Service Bulletin

PRELIMINARY INFORMATION

Subject: Rattle From the Turbocharger on Cold Start

Brand:	Model:	Model Year:		VIN:		Engine:	Transmission:
		from	to	from	to		
Cadillac	CTS-V Sport	2014-2016		All	All	LF3 Turbo	All
Cadillac	XTS	2014-2016		All	All	LF3 Turbo	All

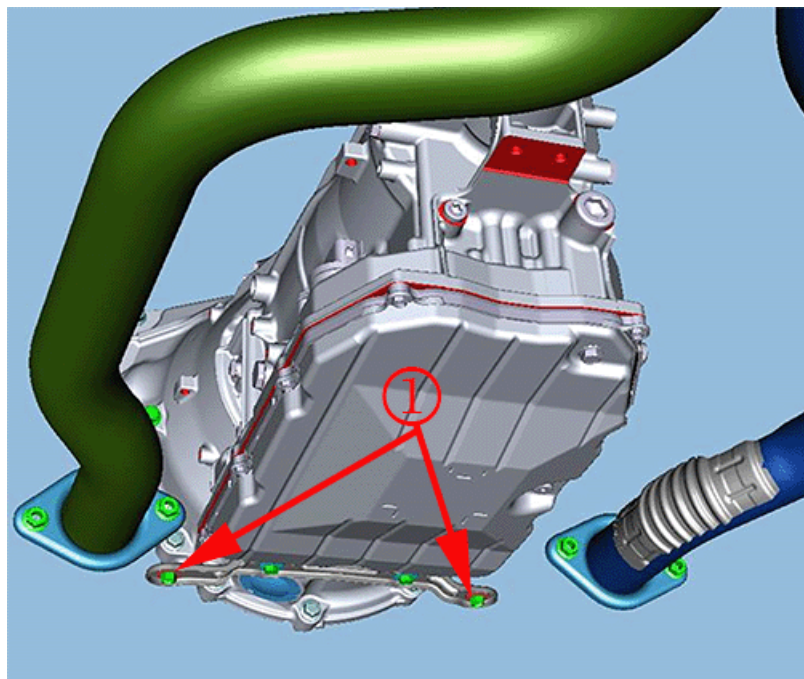
Inspect the exhaust converter bracket nuts that secure the converters to the bracket prior to replacing any parts.

Inspect the M8 nuts noted in the picture that secure the catalytic converters to the exhaust bracket.

Over time during normal operating conditions these nuts can lose torque and cause a rattle that sounds like it is coming from the turbocharger.

If technician finds the M8 nuts are loose it will be necessary to replace them with new torque prevailing nuts, P/N 11546441 LF3 (2 nuts).

If the technician finds that the nuts are torqued correctly this is not the issue.
